**Report to the Future Melbourne (Planning) Committee**

**Agenda item 6.3**

**Planning Permit Application: TP-2015-587  
22-24 Wells Place, Southbank**

**DELEGATED PLANNING APPLICATION REPORT**

TITLE GROUND FLOOR PLAN

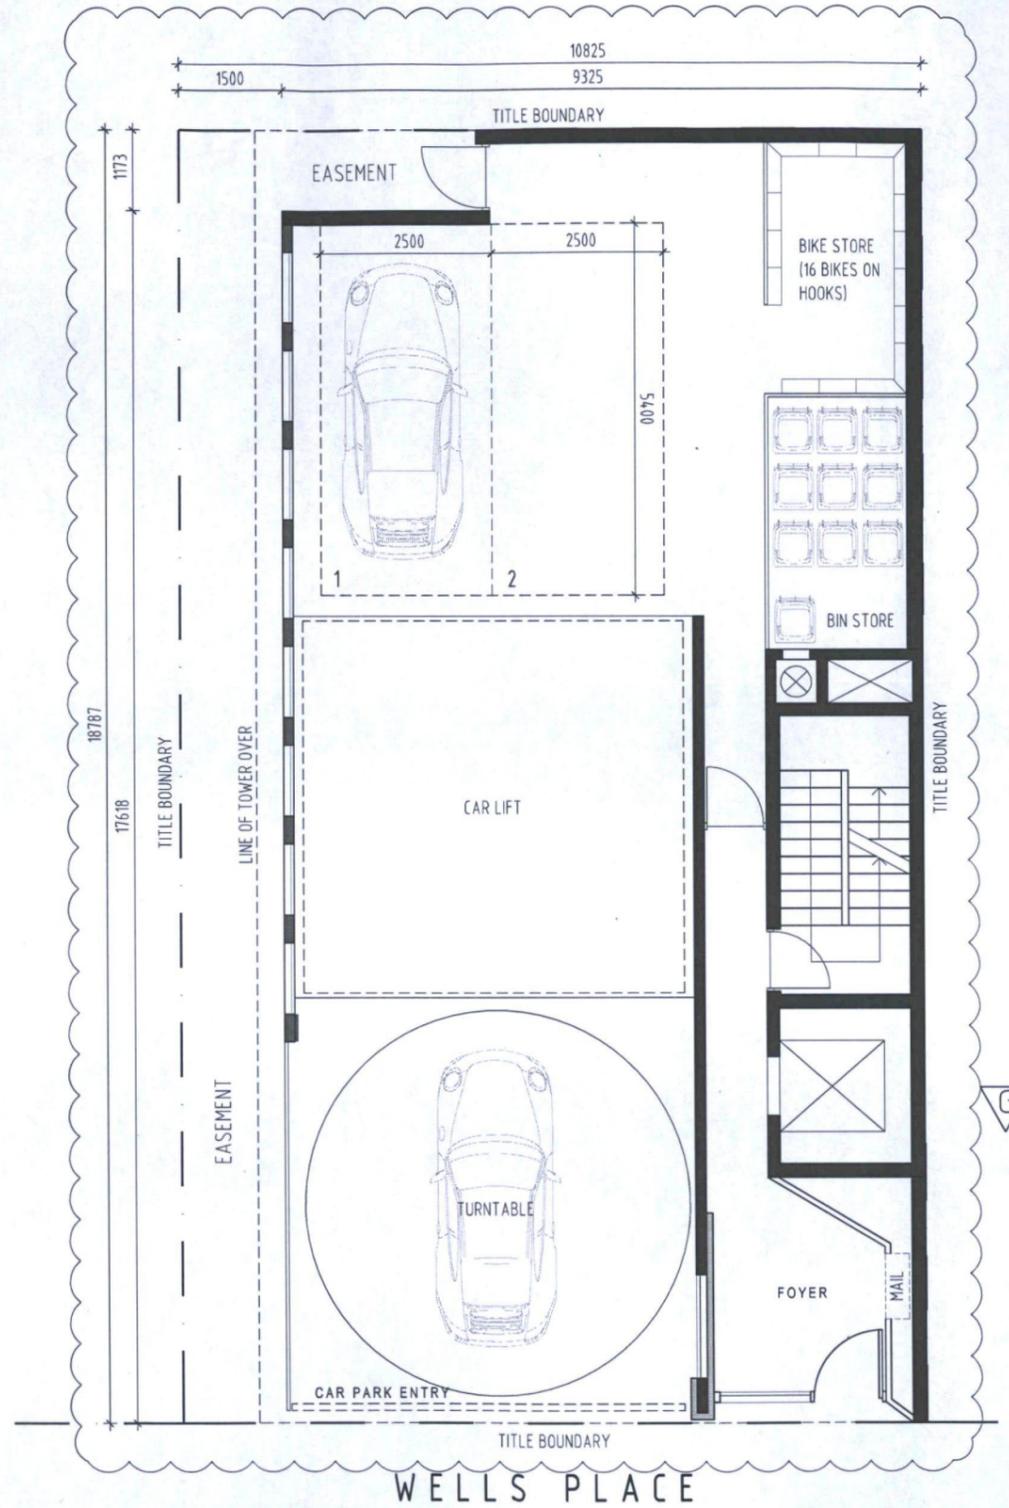
- There are different ground floor plans in the WMP (4 bins) and in the 'planned' ground floor (shows 10 bins). This needs to be rectified and the chute must be clearly drawn in relation to bin locations. Both plans need to align to ensure built form matches the WMP.

- o Plans indicating the bin storage area and the chute must be clearly drawn in relation to bin locations.

TITLE PLAN: LEVELS 5 - 8  
PLAN: LEVELS 9 - 19

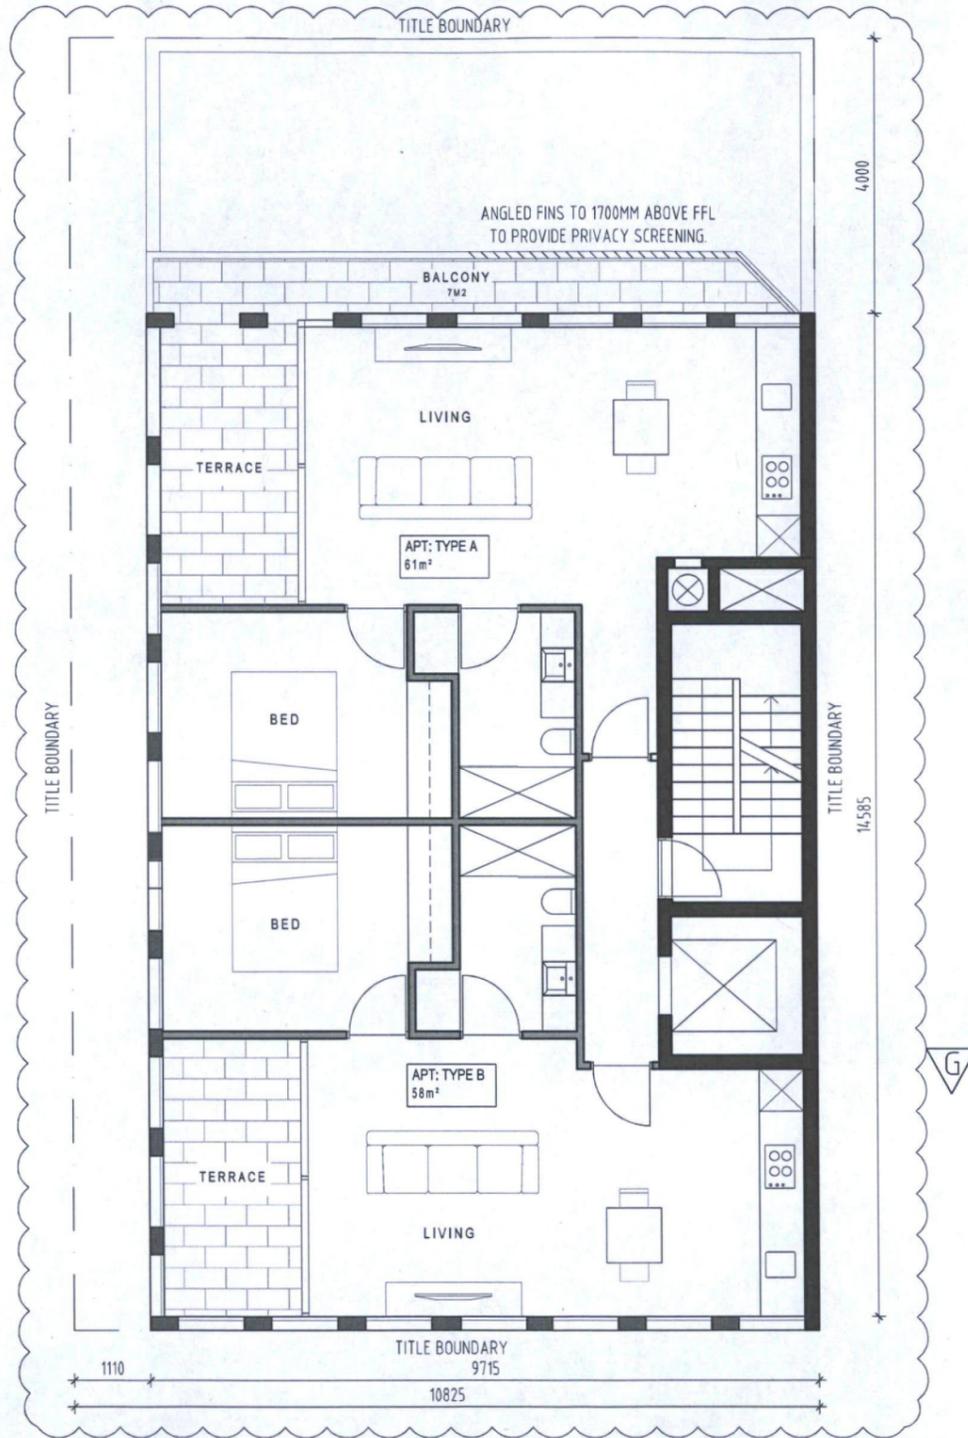
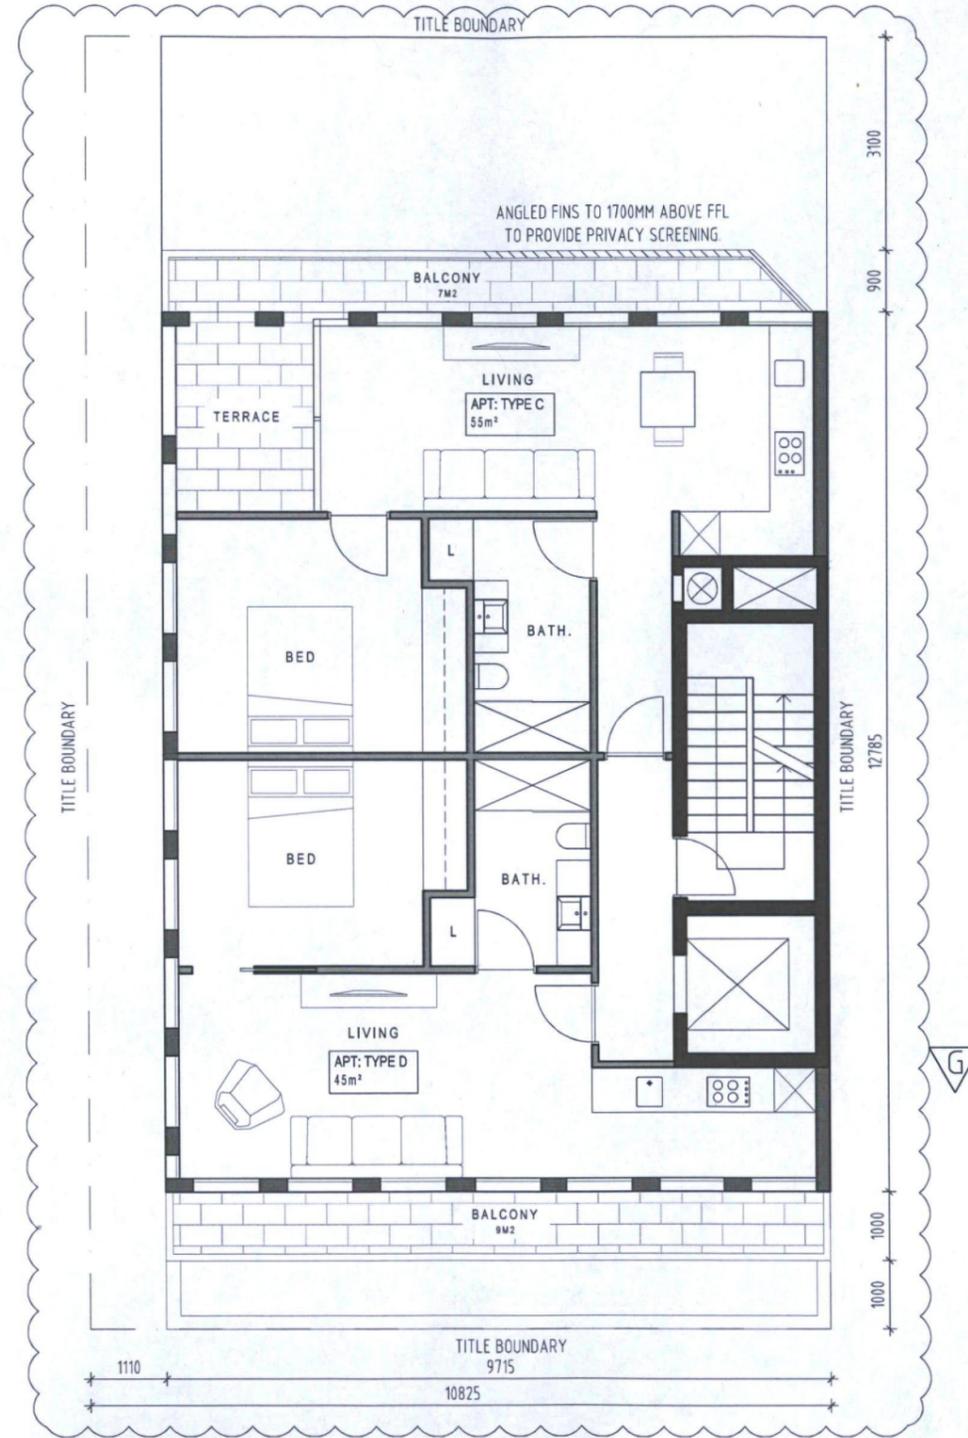
- The introduction of 1m deep south facing balconies (levels 9 and above) which would encroach into the previously approved 2m setback from the southern boundary.

8. The approved development has a 2m setback from the southern boundary at levels 9 and above. The proposed amendments introduce a second 45m<sup>2</sup> south facing apartment at levels 5 and above. Each of these apartments would have a 1m deep, south facing balcony which would project into the previously approved 2m setback. These amendments are not supported as the approved 2m setback from the 4m wide lane (Wells Place) was required to ensure the height of the building did not overwhelm the public domain and provide for equitable development potential of the adjoining property to the south.

9. Removal of the balconies will result in a poorer internal amenity for the small south facing apartments and these apartments should also be removed to provide for only one apartment per level as previously approved.

An additional change is that south facing balconies project 1.0 metre into the 2.0 metre setback from the southern boundary at levels 9 and above.

A reduction in the southern setback will compromise the development potential of the office building to the south of the site.

For the reasons outlined above the planning controls do not support an encroachment into the 2m setback with balconies. The removal of the balconies would remove any access to open space for the proposed 41m<sup>2</sup> south facing apartments.
